1.0 APPLICATION SUMMARY

PD 17-0619 is a 965-acre, non-contiguous PD with three sub-areas: South Fork, Carlton, and Balm. Under PD 17-0619, the Balm sub-area transferred 367 residential units to the South Fork and Carlton sub-areas. This resulted in 1,068 residential units (2.6 u/a) in the South Fork, 426 residential units (2.6 u/a) in the Carlton, and 373 residential units (1 u/a) in the Balm sub-areas. The most recent modification is PRS 20-1315 (approved on 4/13/21) (PRS 21-0245 was approved on 3/11/21).

This PRS relates to Balm sub-area, specifically Pocket A. The Balm sub-area consists of six pockets, which primarily permit single-family development. The Balm sub-area was already approved for 10,260 sf of CG zoning district uses in the now Pockets C and D. Pockets C and D are located and the northwestern area of the PD along CR 672. Because the previously approved commercial did not meet the distance requirements to 90% of the residential, it was not used to meet the Village Node square footage requirement. Therefore, the site was required to provide 7,431.75 square feet of neighborhood retail uses in a Village Node meeting the internal distance requirements within Pocket A (

8.2 Proposed Site Plan (Full)

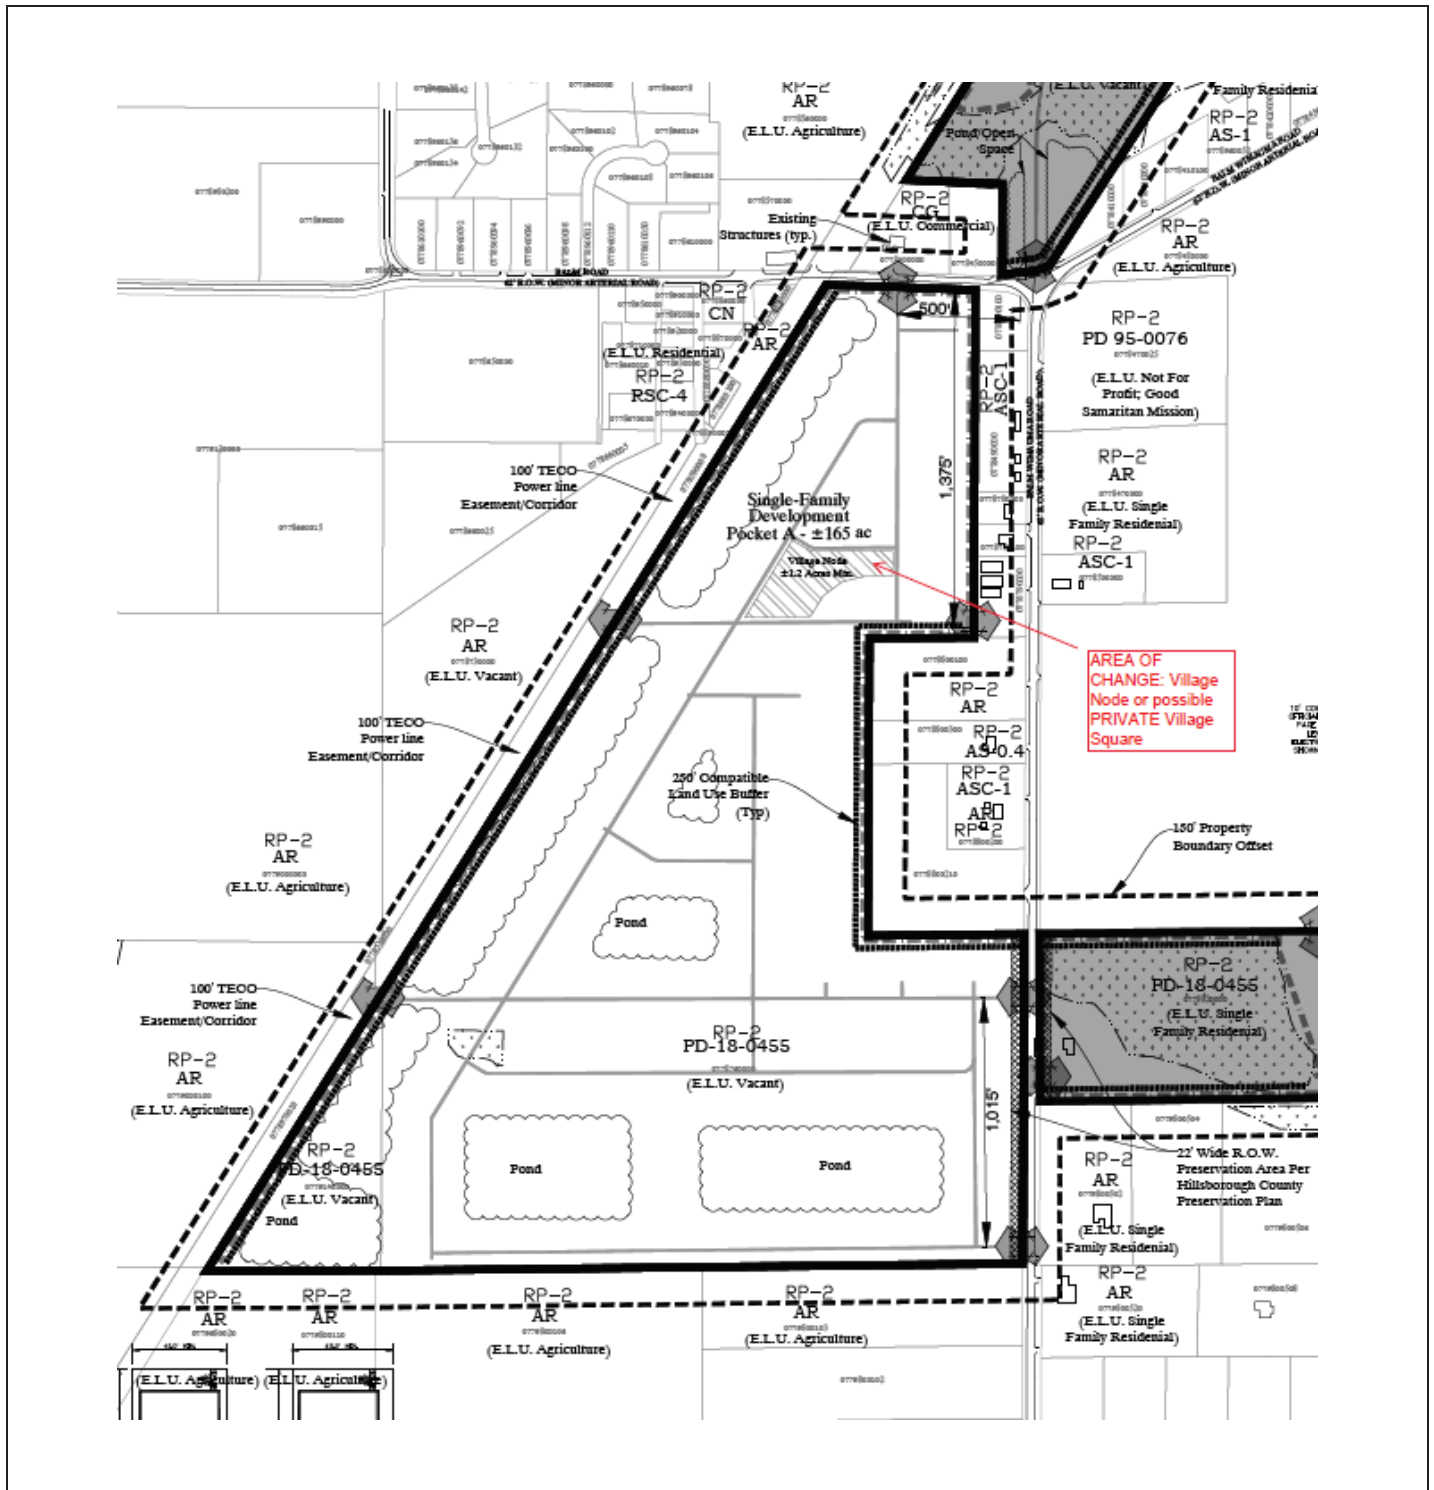
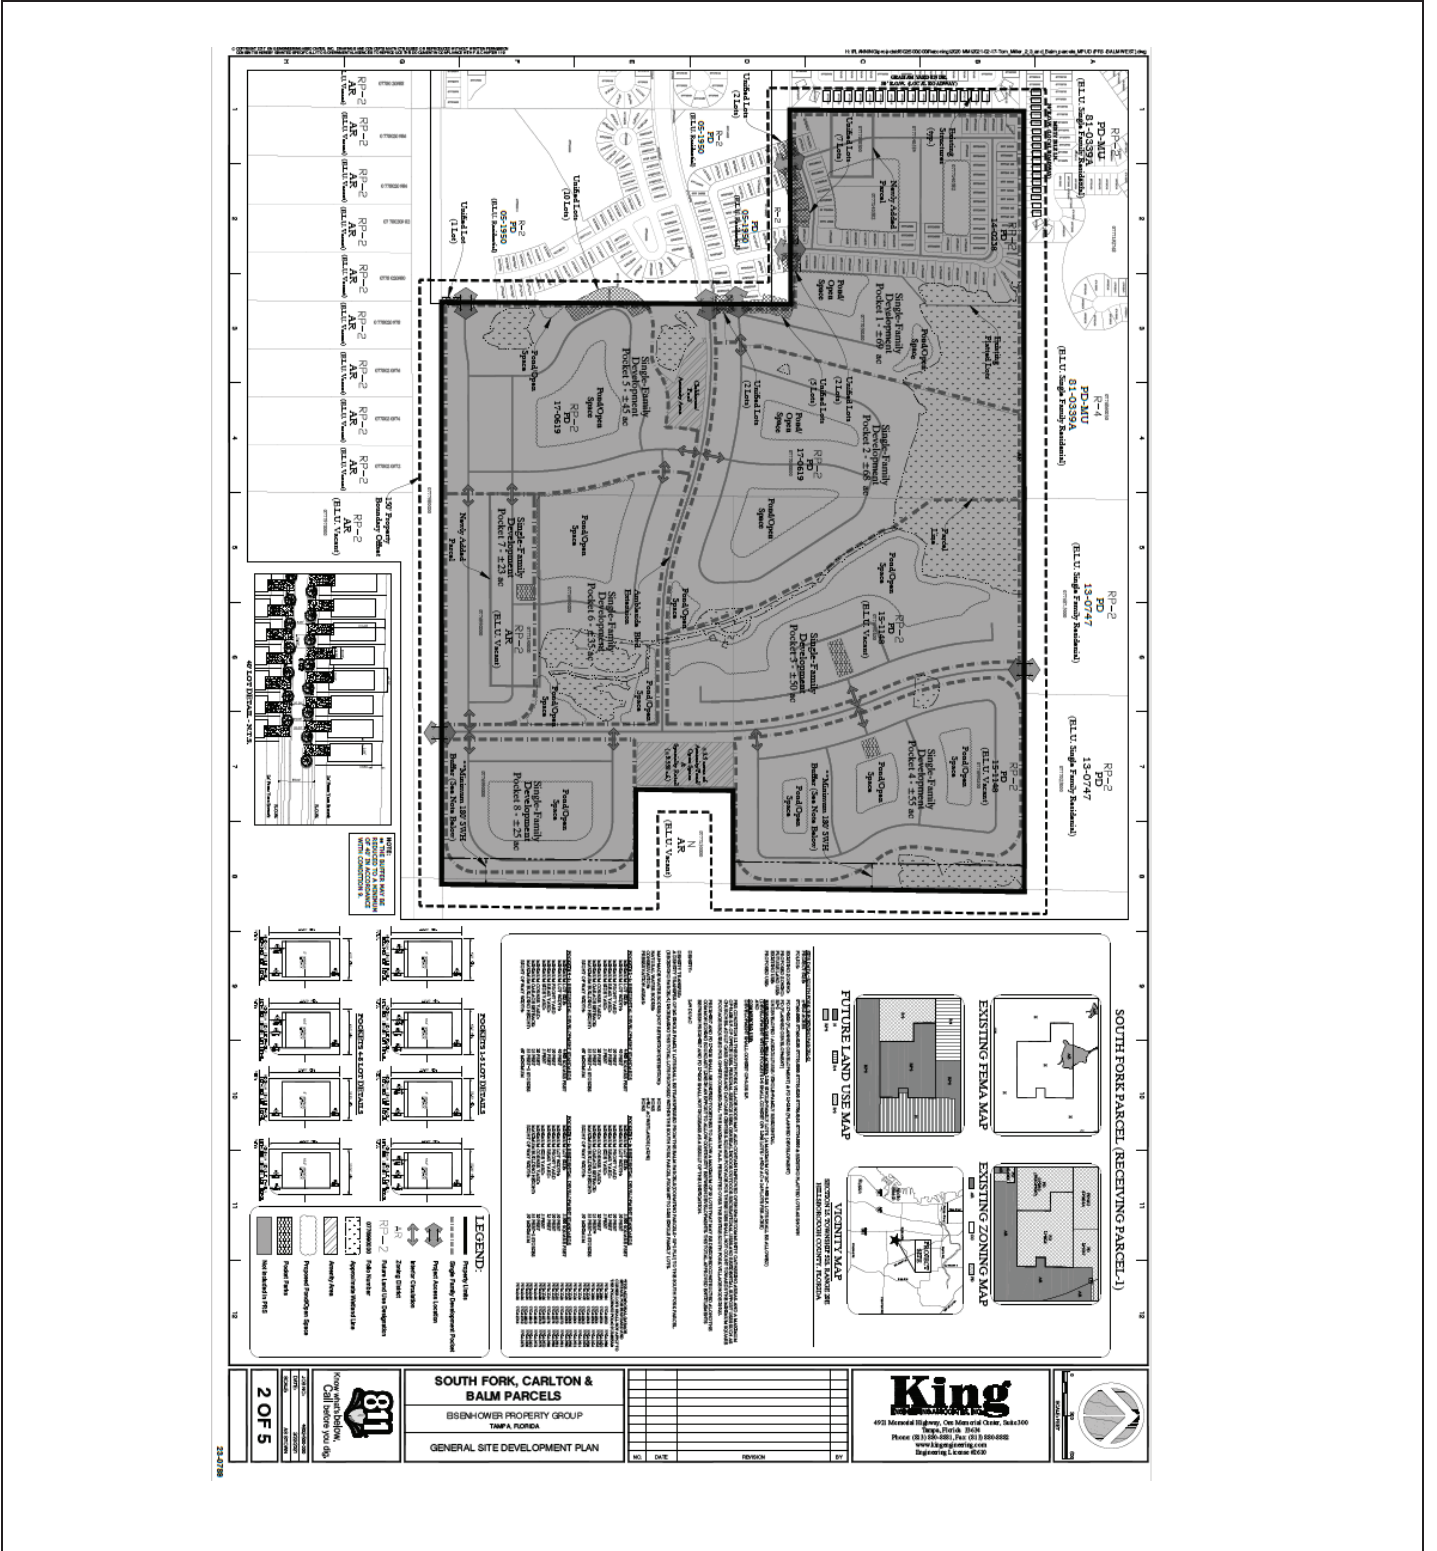
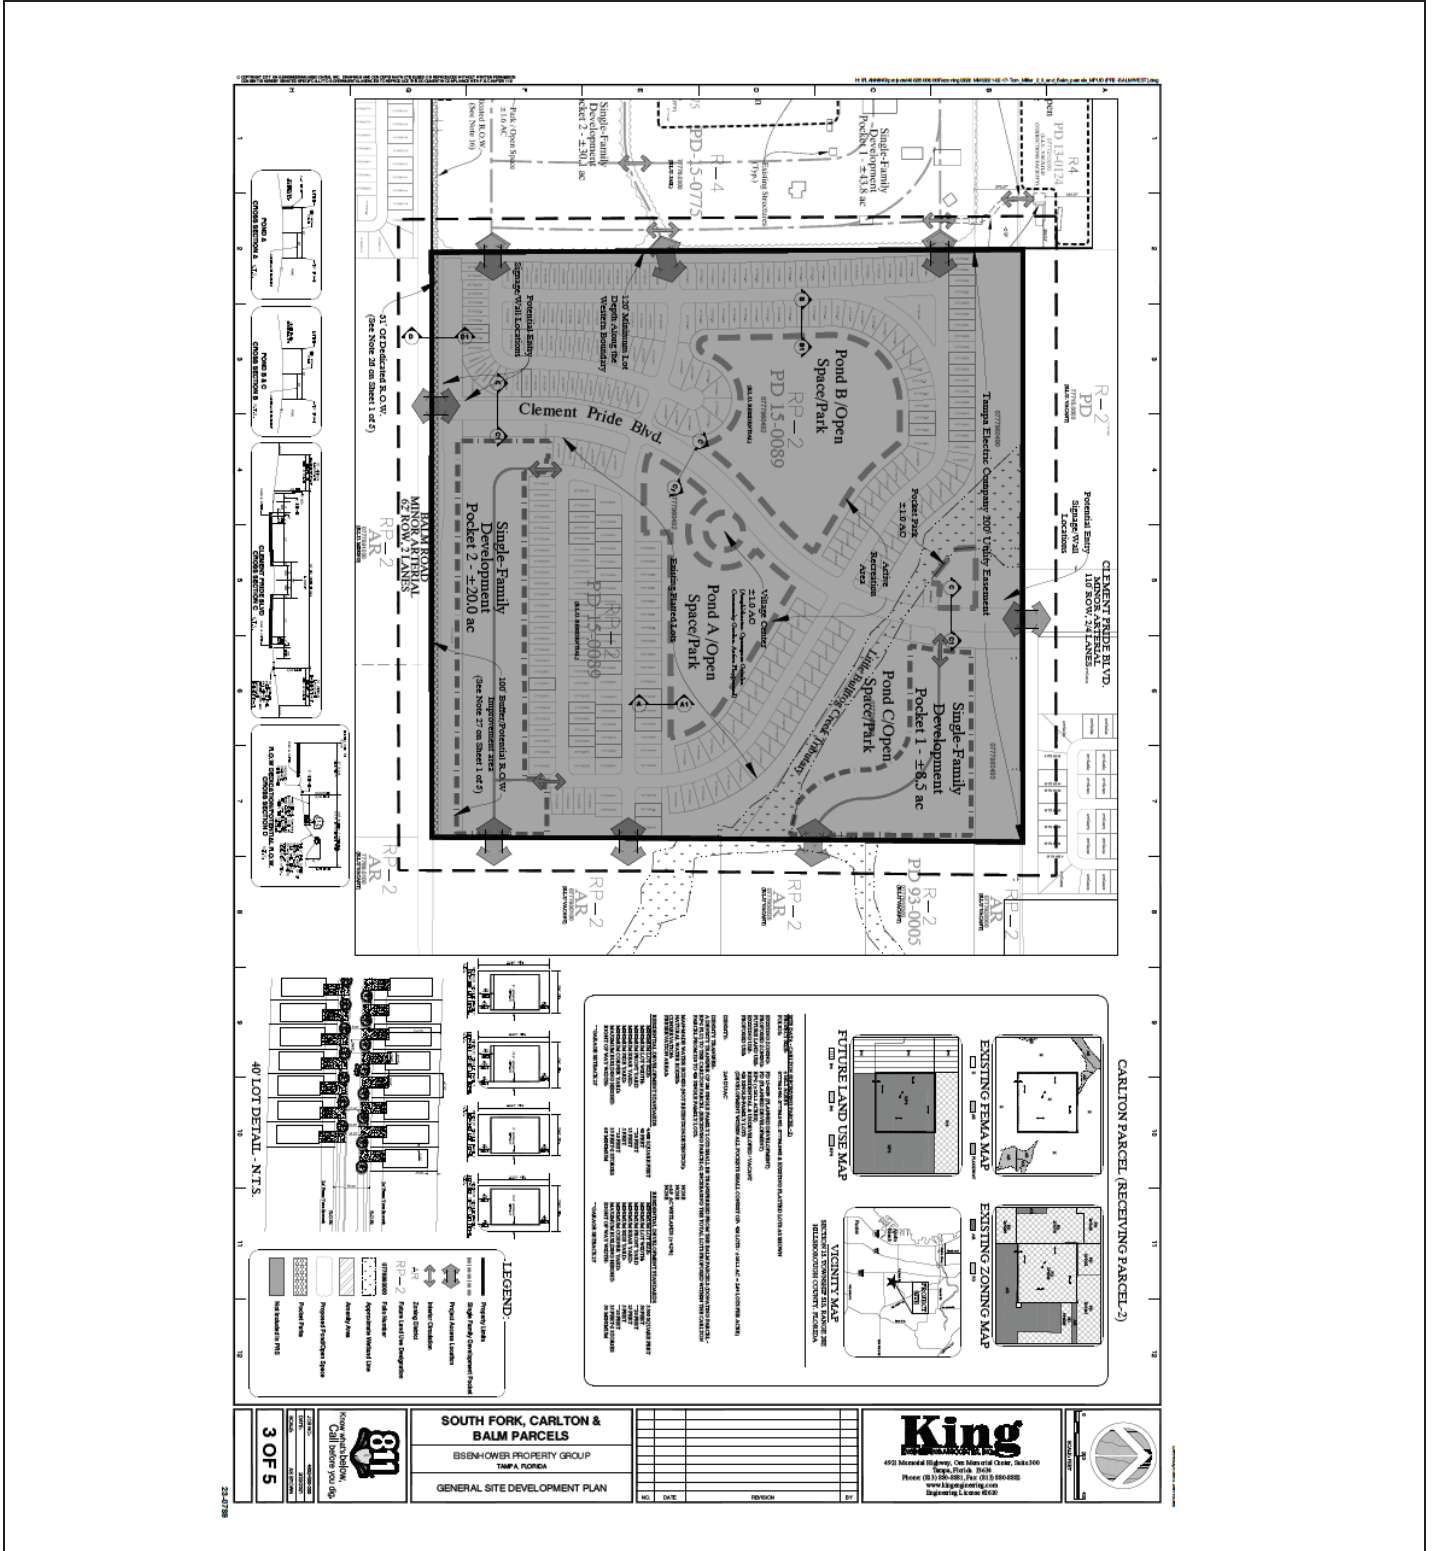
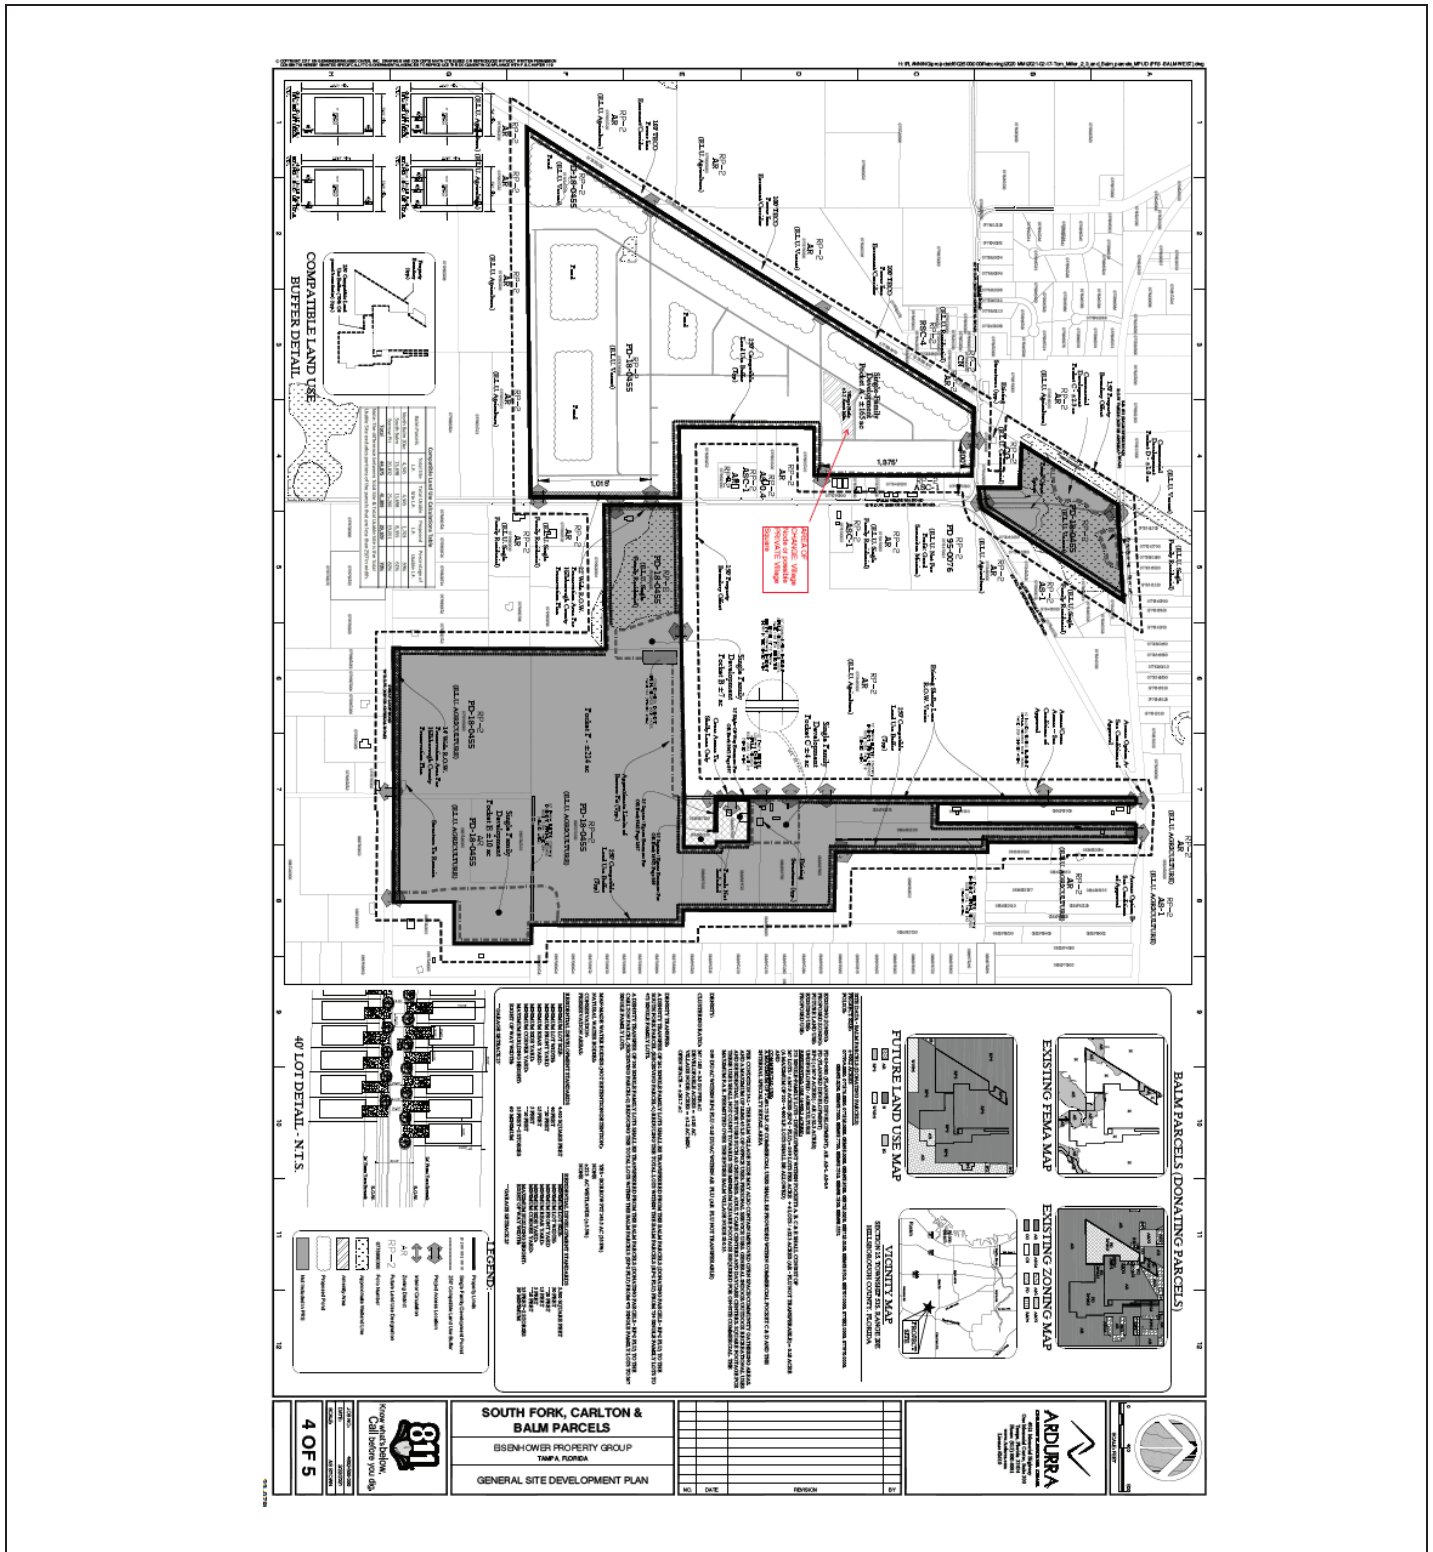
Based on the above, staff has no objection to the proposed request; however, staff notes that the conceptual site plan submitted should not be considered a binding site plan (since it does not meet DRPM

requirements and would conflict with the retained option to build commercial uses). Instead, the applicant must submit a revised site plan prior to certification which shows the area in question and labels the area according (e.g. “Proposed Village Node/ Village Square – See Conditions of Approval”).
